National Committee on Uniform Traffic Control Devices

NCUTCD Proposal for Changes to the Manual on Uniform Traffic Control Devices

TECHNICAL COMMITTEE: Railroad/Light Rail Transit Technical Committee
ITEM NUMBER: 19A-RR-01
TOPIC: Mounting Height of Crossbuck and Tracks Signs on Flashing-Light Signals
ORIGIN OF REQUEST: RR/LRT Technical Committee
AFFECTED SECTIONS OF MUTCD: 8C.02

Figure 8C-1. Composite Drawing of Active Traffic Control Devices for Grade Crossings Showing Clearances

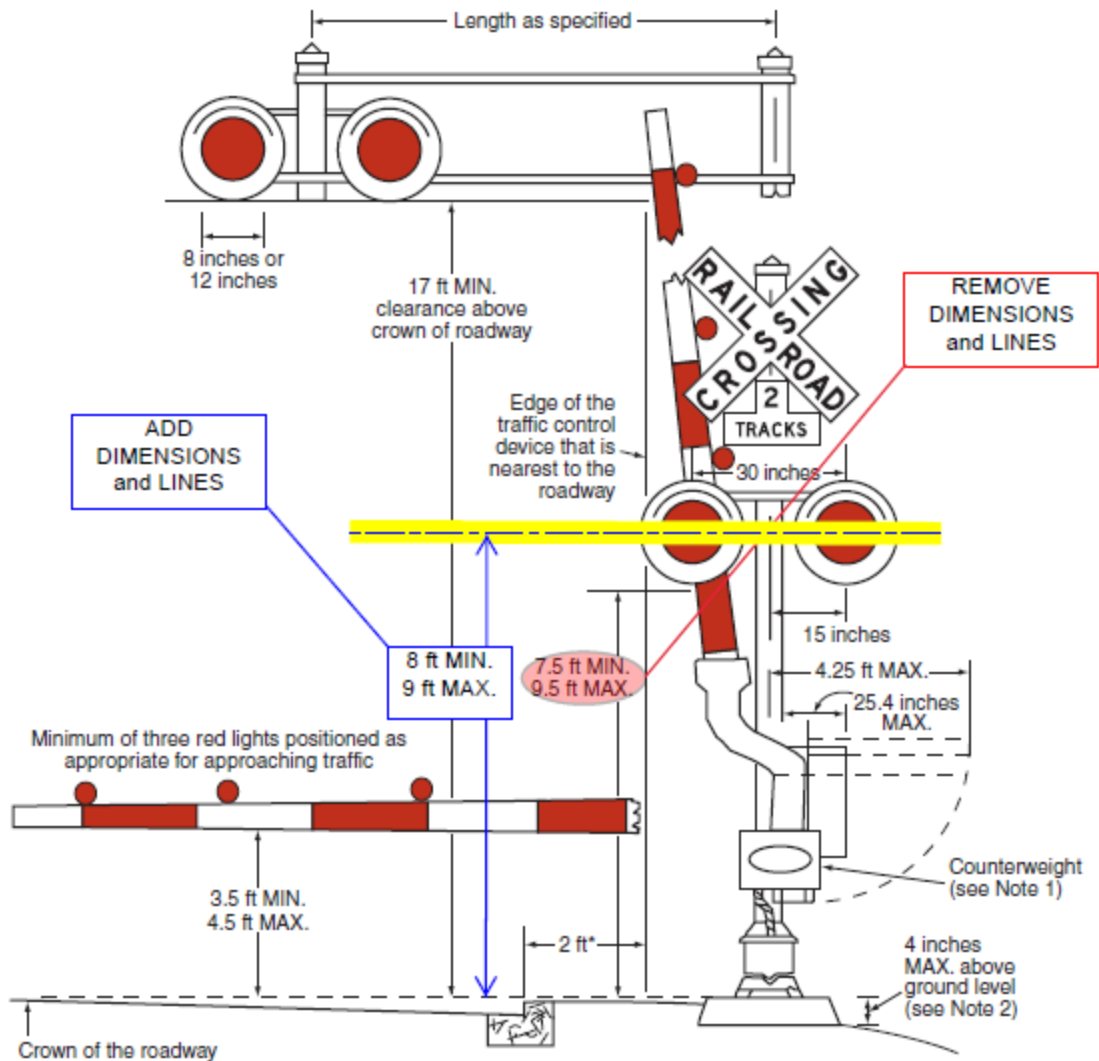
Existing guidance statements in section 8C.02 and in Figure 8C-1 provide many dimensions for the components of flashing-light signals. No dimensions are provided for the mounting of the Crossbuck and Track signs. Where multiple sets of flashing-light signals are used, the mounting location of the Crossbuck and Track signs may become too high to be visible to drivers or be illuminated by vehicle headlights. The proposed changes provide guidance to improve the visibility of the signs. The proposal makes changes to section 8C.02 and Figure 8C-1 that were previously approved by the NCUTCD Council as item 14B-RR-04 in June 2014.

55 02a The bottom of the Number of Tracks (R15-2P) plaque (when used) should be located as low
56 as practical above the flashing-light backgrounds. The Crossbuck (R15-1) sign should be located
57 just above the Number of Tracks (R15-2P) plaque or, if no plaque is present, the bottom of the
58 Crossbuck sign should be located as low as practical above the flashing-light backgrounds.
